Re: **Nestucca Valley Elementary School (PWS ID #90595) New Well #4
Site Plan Approval (PR #44-2019)**

Nestucca Valley Elementary School (PWS #90595) – New Well #4 Site Plan Approval (PR#44-2019)
April 26, 2019

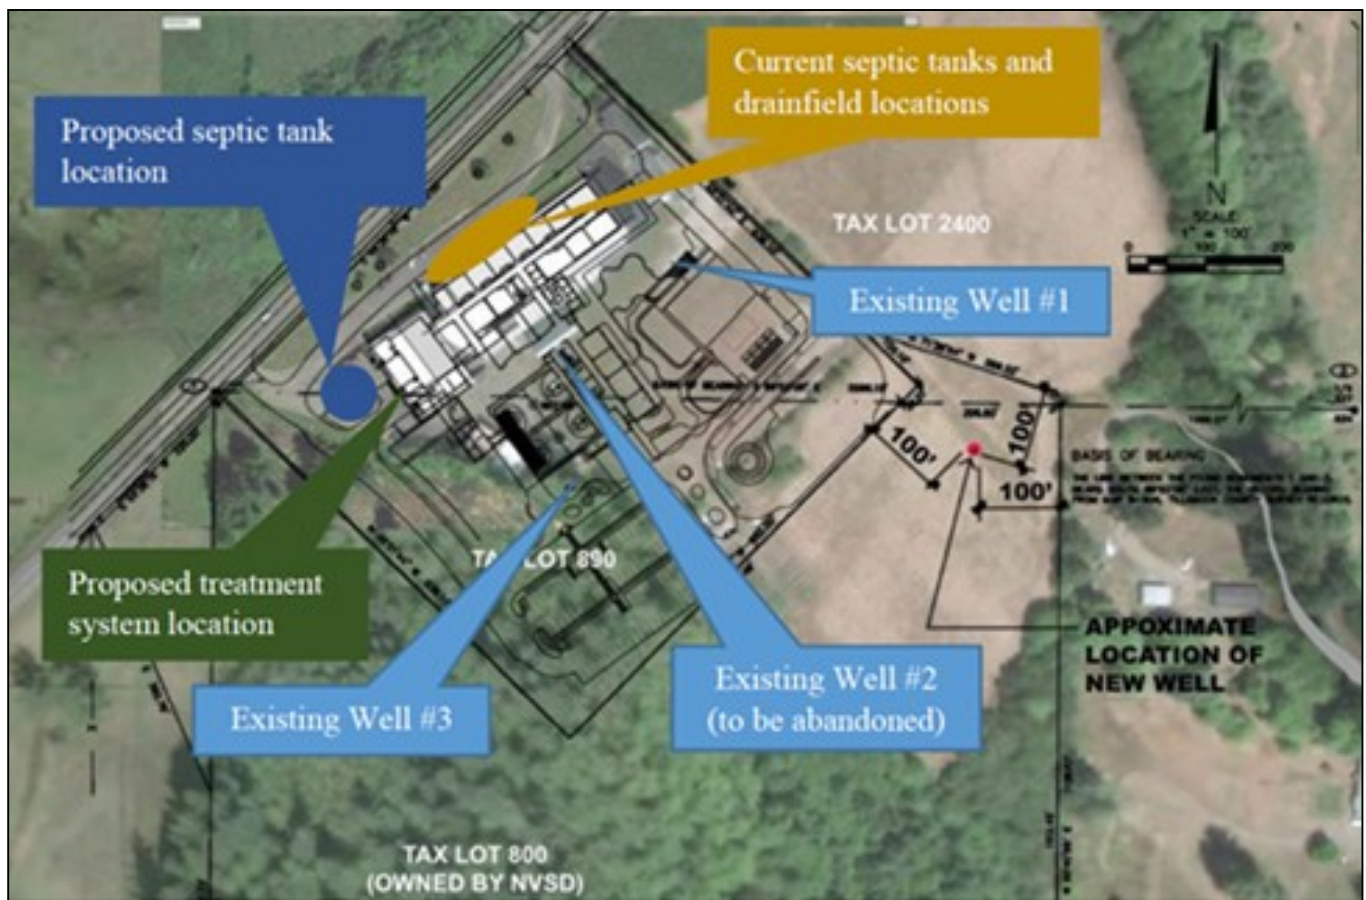
Based on a revised site plan which was e-mailed to me on April 25th, 2019, the revised site plan for the new well #4 is approved. The revised site plan shown (in part) to the right allows for the new well to be located 100-ft away from any hazard (including the bus parking lot) and within the existing land owned by the school as well as a new parcel at the eastern corner of tax lot 2400 and tax lot 890 to be acquired by the District to achieve the 100-ft radius of control (ownership) around the proposed well #4.

“Based on the well logs for the existing Nestucca Valley Elementary School wells, the water-bearing zone in this area is associated with a sand and gravel deposit that is roughly 80 to 90-ft below ground. The aquifer at this location is likely to be unconfined, therefore the 100-ft radius around the proposed well site should be clear of any sanitary/chemical hazards. The depth of the casing seal should be determined in accordance with Oregon Water Resources Department [WRD] standards [OAR Chapter 690, Division 200]. OHA Drinking Water Services recommends sealing the well casing 5-ft into the silt/clay and gravel layer directly above the targeted water-bearing zone described in well logs TILL918 and TILL919 as occurring at a depth of roughly 41 to 61-ft below ground.”

This information is anticipated to apply to the new well location (shown in larger detail below) and should be shared with the well driller.

Nestucca Valley Elementary School

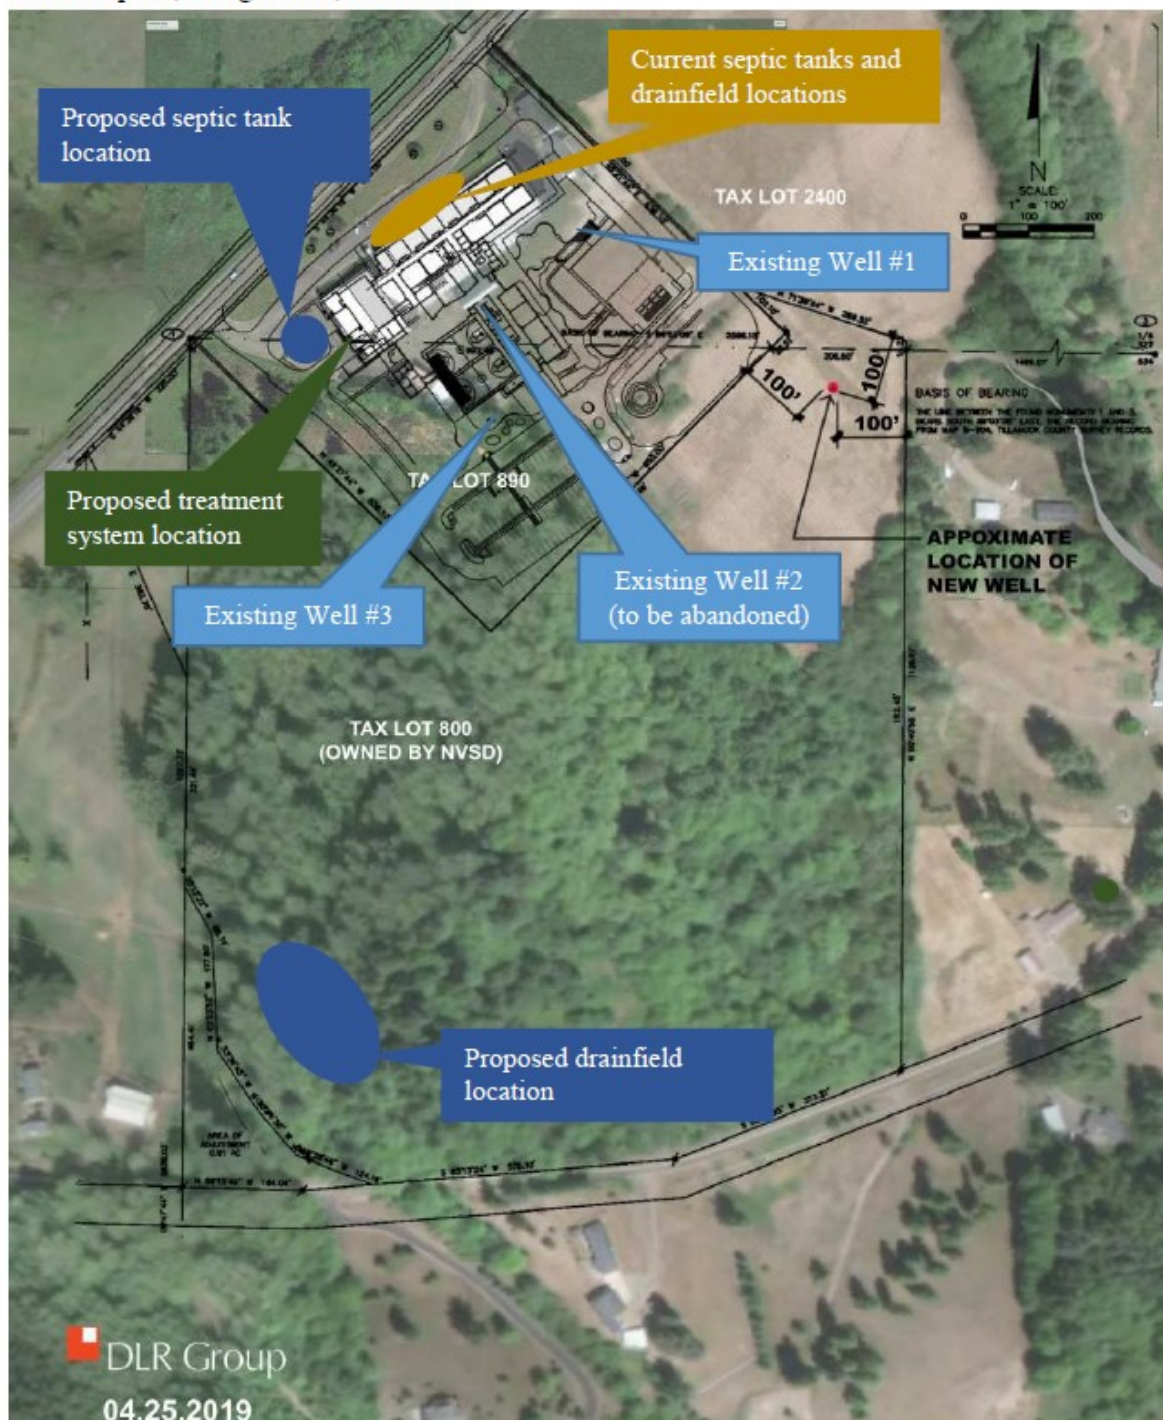
After some discussions with the District, they are acquiring a small parcel of land at the eastern corner of tax lot 2400 and tax lot 890, as shown in the attached plan. The acquisition should be completed in early May. Therefore, we have moved the proposed well location slightly to incorporate the required setbacks of 100 feet from the property lines and the parking lot.
